**Town of Aurora
Accessibility Advisory Committee
Meeting Agenda**

Re: Condominium Application CDM-2024-02 (Submission #1)
1588 St. John's Sideroad

Re: Zoning Bylaw Application ZBA-2024-06 (Submission #1)
240 Industrial Parkway South

Re: Site Plan Application SP(EX)-2024-15 (Submission #1)
14987 and 14993 Yonge Street

1 BLOCK 5&6 - BUILDING "I" SITE PLAN
SCALE: 1:300

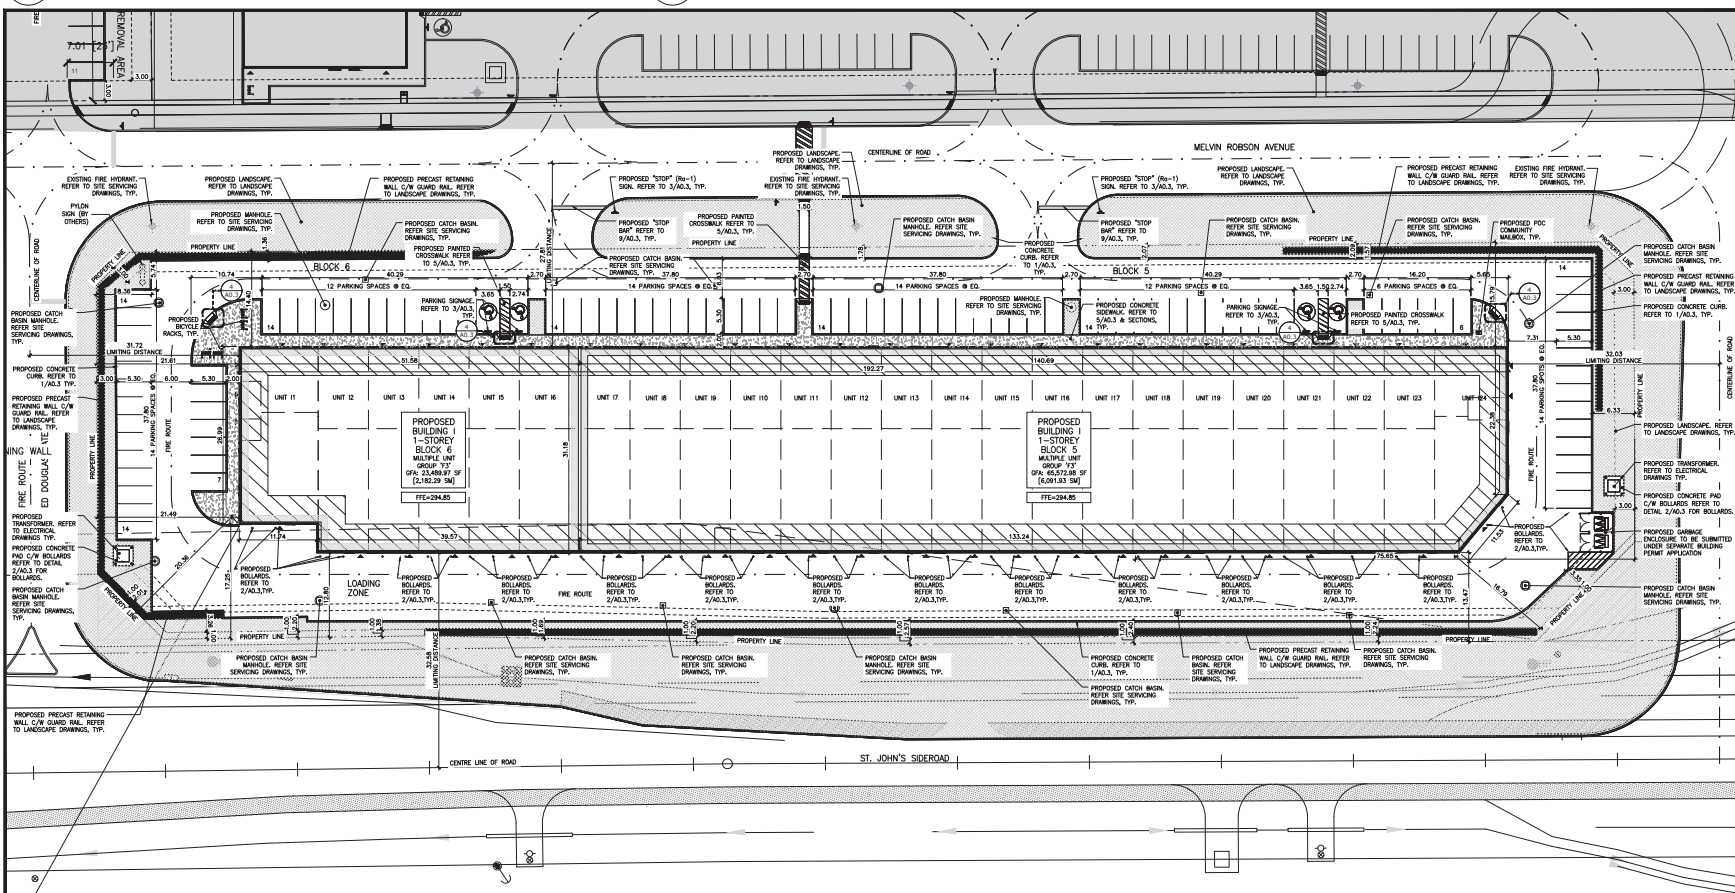
- For units with customer service counters, consideration for an accessibility spot and induction loop.
- Although the four (4) Barrier-Free Parking spaces meet the parking minimums, recommend two (2) additional spaces by Unit 11 and Unit 12 to reduce the travel from the existing spaces to the middle of the building.
- Where a curb ramp meets the exterior path of travel (at each barrier-free access aisle), ensure 1200mm from the top of the curb ramp to the end of the building to avoid a cross slope across the path.
- Automatic door openers for all public access locations, including proper timed door delays
- Should there be a washroom on main level and available to the public, ensure it is served by the barrier-free path of travel and to be a universal washroom.

- To ensure visibility on doors and windows, ensure a continuous, colour contrasting opaque strip on the glass.
- It appears there is a flush, level entrance to each unit. If not, ensure every public entrance is accessible to enter.

NOTES	ISSUED FOR	CONSULTANTS	ARCHITECT	PROJECT	DWG TITLE	SCALE
	ISSUED FOR ZBA APPLICATION			Richland Academy Middle and Senior School	Accessibility Design Standards Plan	N.T.S.
				240 INDUSTRIAL PARKWAY SOUTH AURORA, ONTARIO		DATE MAY 2024
				DEVELOPER	DRAWN BY S.Z.	JOB # DWG No. SP 08

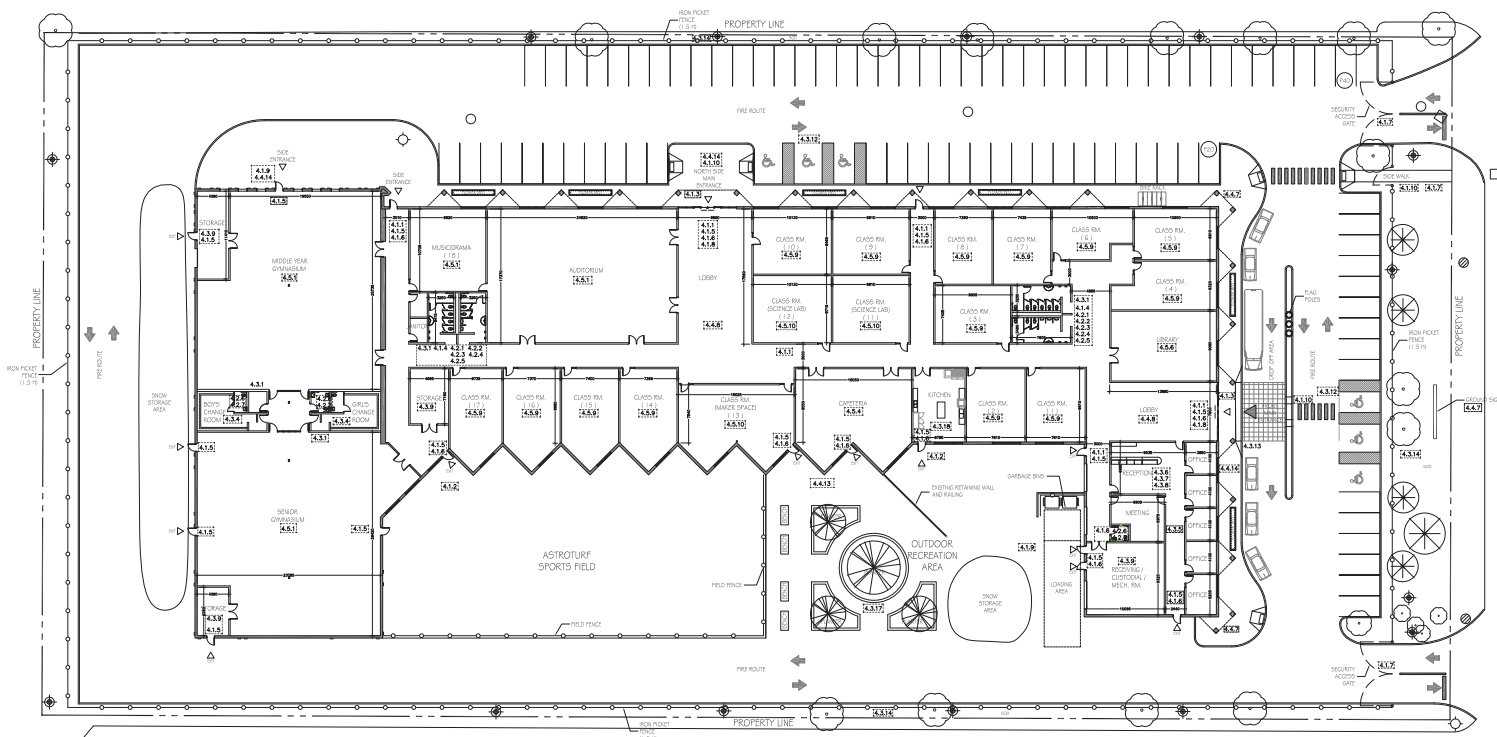
- The three (3) universal washrooms placements are in good locations. As mentioned, prior to final approval, please ensure these spaces are large enough as they currently look like a small space.
- Many items listed are focused on student accommodations. Also consider many of the accessible features to also be for staff, parents, and visitors.
- Consider the flower beds and bike rack to not impede the path of travel on the North side.
- Astroturf fields can be challenging to traverse for individuals with mobility disabilities. Consider a firm path of travel around the exterior, or where appropriate.

DRAWING TITLE:
 GROUND FLOOR PLANS

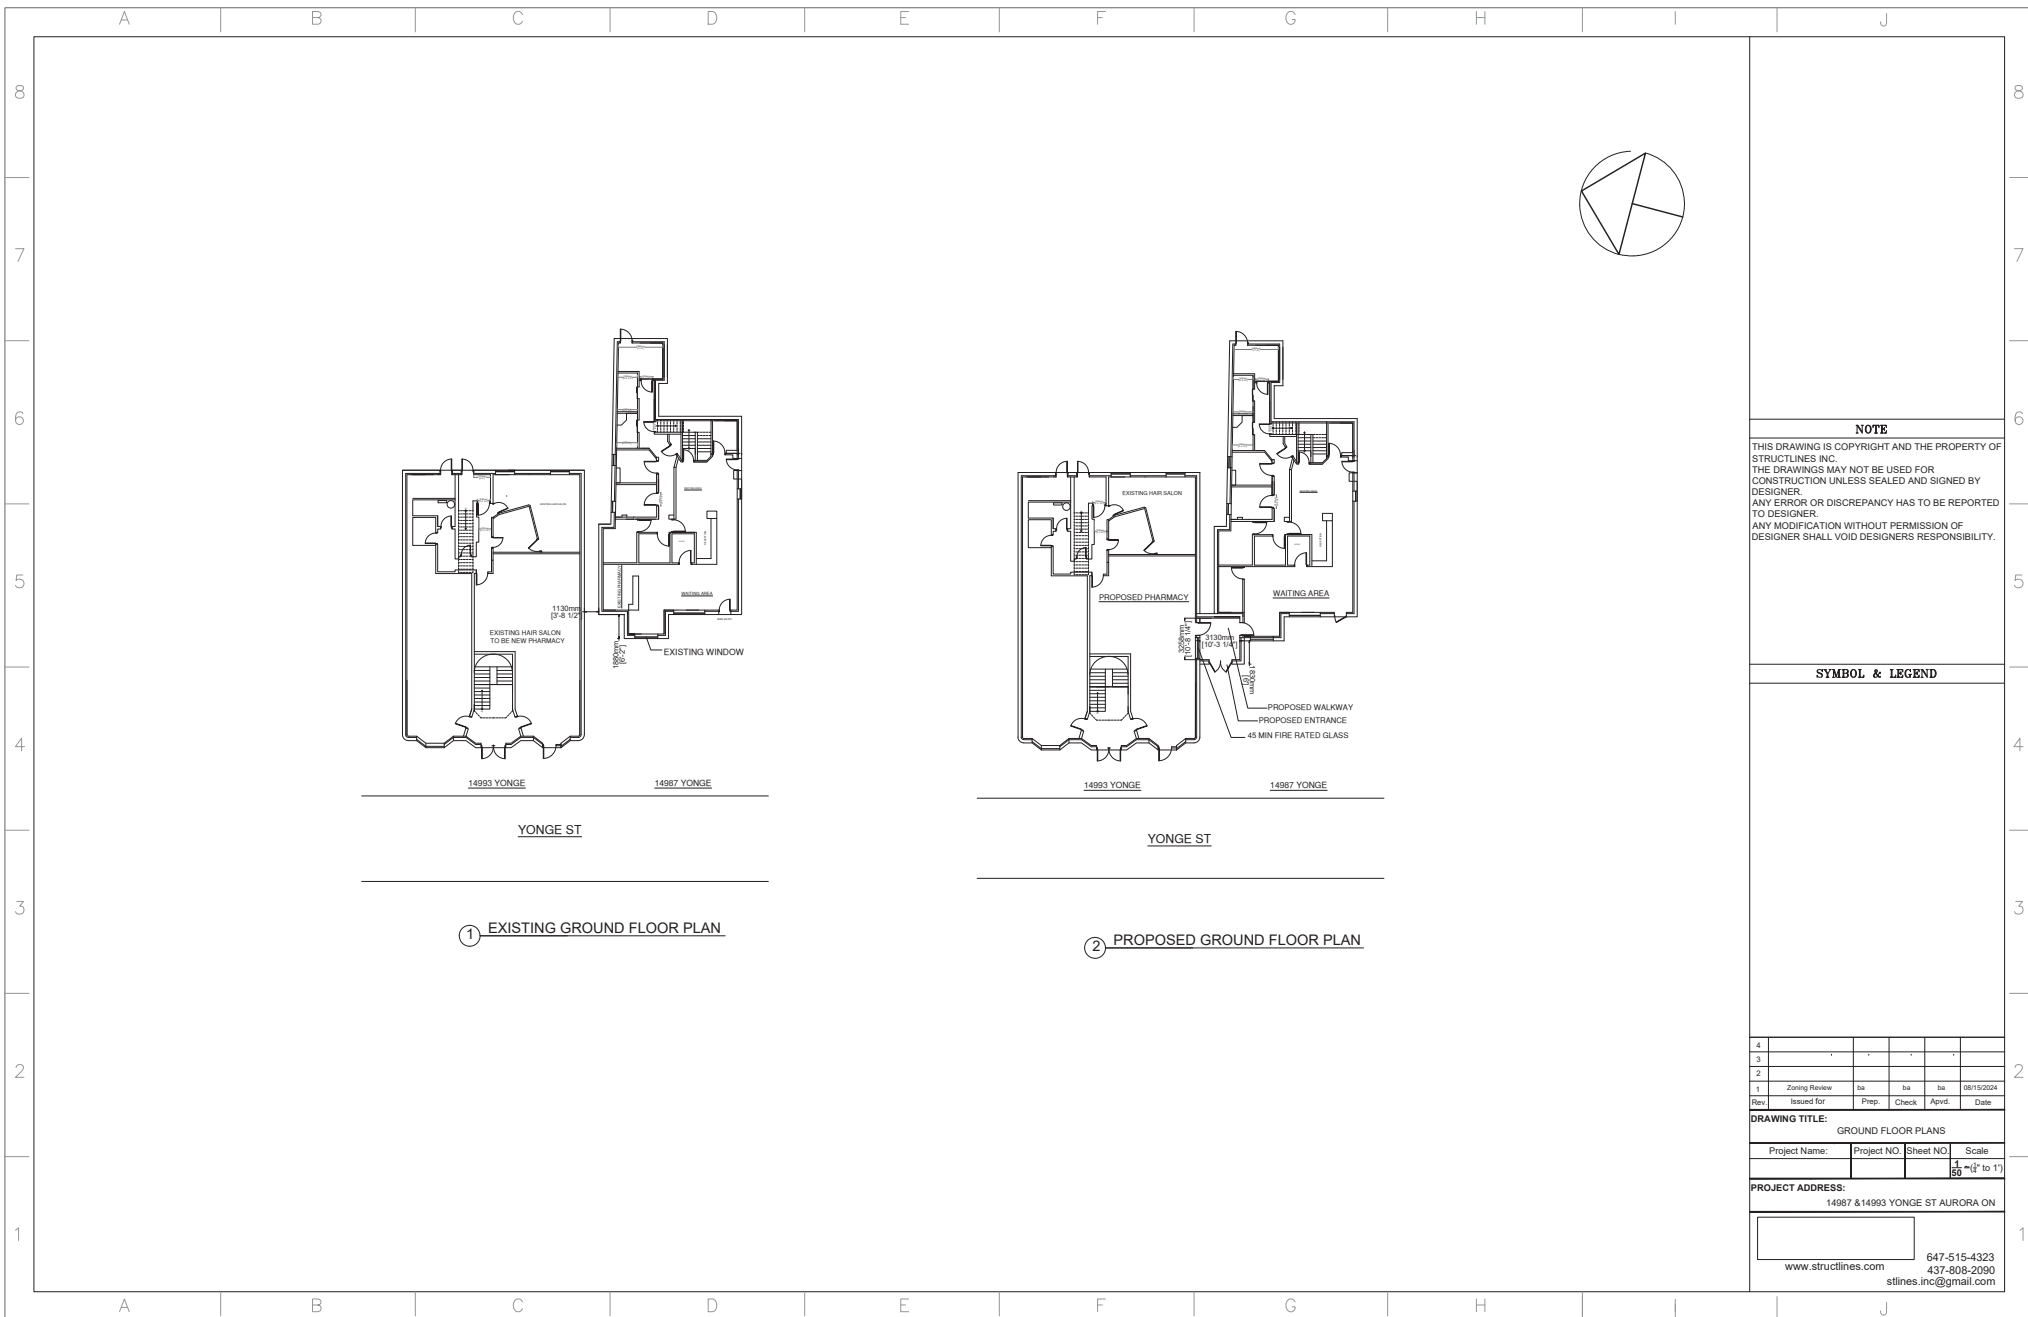
- Automatic door openers for new public access locations, including proper timed door delays.
- Customer service counter to have an allocated accessibility spot and consideration for an induction loop in the proposed pharmacy.
- Recommendation to add (or convert) one (1) additional Barrier-Free parking space to comply with the Accessibility for Ontarians with Disabilities Act.
